***GE Medical Systems***

**Direction 2358586-100**

# **GE Medical Systems LightSpeed Plus & Ultra Gantry Display ESD Rework**

**Figure 3. Locate Screw Hole and Remove Board Coating**

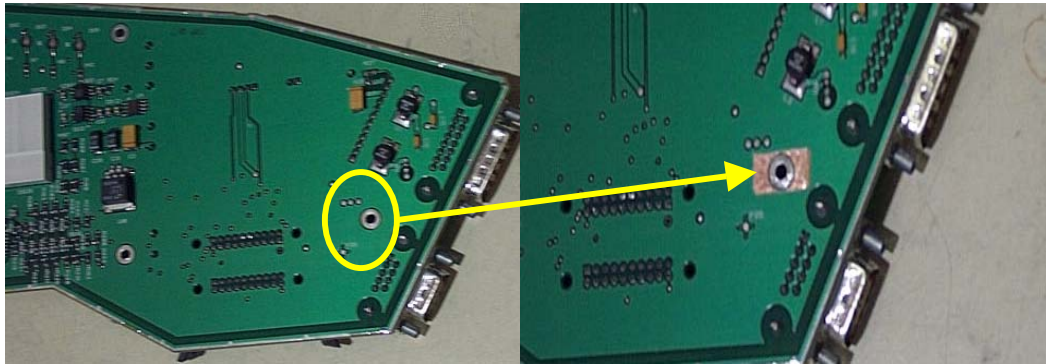
7. Refer to Figure 3. On the front of the display board, locate the screw hole near the connectors as shown. *Carefully* remove the board coating by scraping it away with the blunt tip of a flat blade screwdriver.

8. Refer to Figure 3. Cut a piece of copper tape to fit inside of the scraped away area. It should be sized to leave sufficient room for the application of solder.
9. Refer to Figure 5. Apply solder to the copper tape to fasten it to the display board.

**Figure 4. Cut An X**

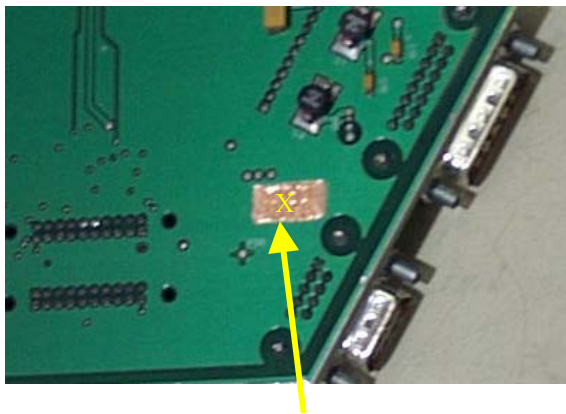
10. Refer to Figure 4. Locate the hole through the tape and, using a sharp Exacto knife, carefully cut an X into the tape over the screw hole.
11. Fold over the copper tape into the hole.
12. Use one of the standoffs to force the tape to conform to the hole's dimensions by forcing it into the screw hole.
13. Add "-2" to the end of the part number imprinted on the board with an indelible ink pen (so it reads: "2256730-2").
14. Reassemble the display by reversing steps 5 and 6.
15. Perform a continuity check from the metal cover to the connector shell to ensure a good electrical connection.
16. Reassemble the display to the gantry cover.
17. Put front cover back on and turn the Axial Drive switch on.
18. Put top and side covers back on.
19. Perform a hardware reset and test scans.
